IEEE 802.1ap Draft 2.1

July 18, 2007

Implemented comment resolutions

> *ieee8021BridgeBaseComponentType*

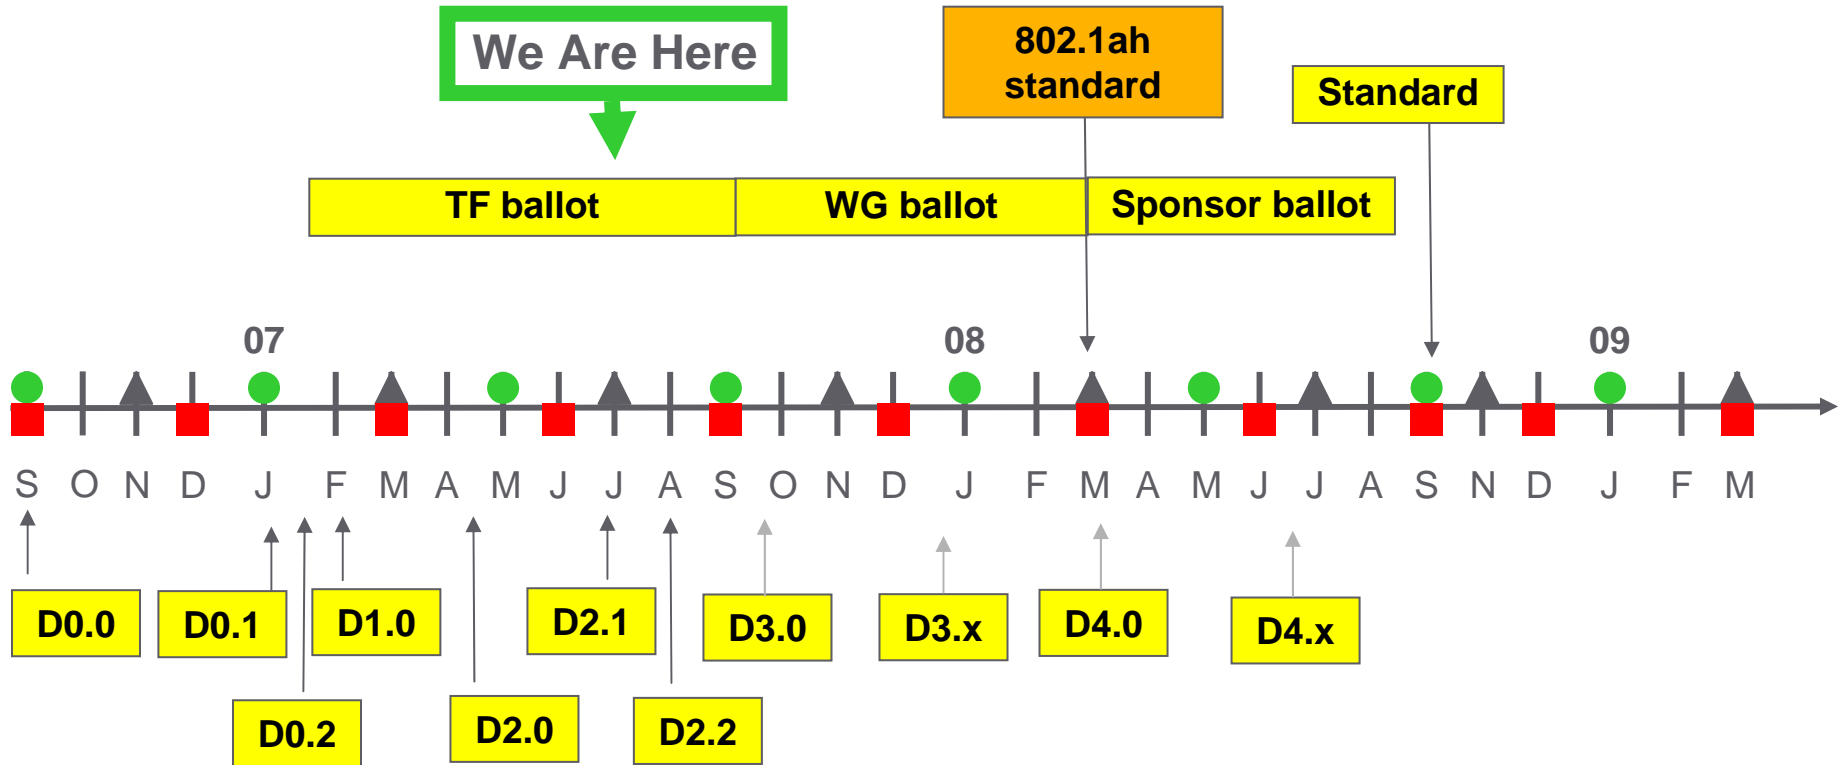
Add the following:

12.3 m) ComponentType, an enumerated list used to classify a particular VLAN-aware bridge component within a system comprising multiple components. The options are: C-VLAN component, S-VLAN component, I component & B component
